**PCN: V15-001-00475504-OA**

## **Product Change Notice**

HSDL-9100-021, HSDL-9100-024 and options.

Figure 1: Comparison of the current HSDL-9100 with laser marking and new HSDL-9100 without laser marking.

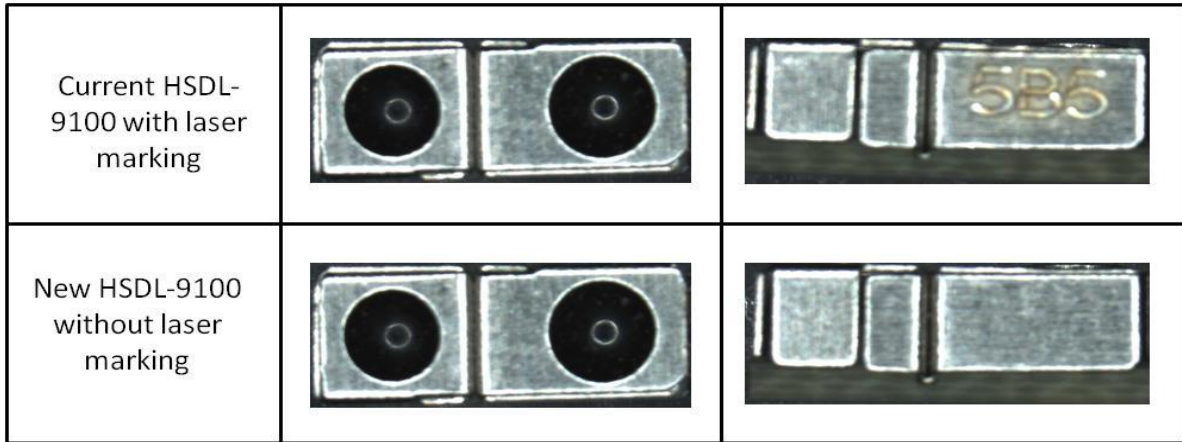
Remove laser marking on the product.

The photos below show the exterior package of the current devices for current HSDL-9100 with laser marking and new HSDL-9100 without laser marking.
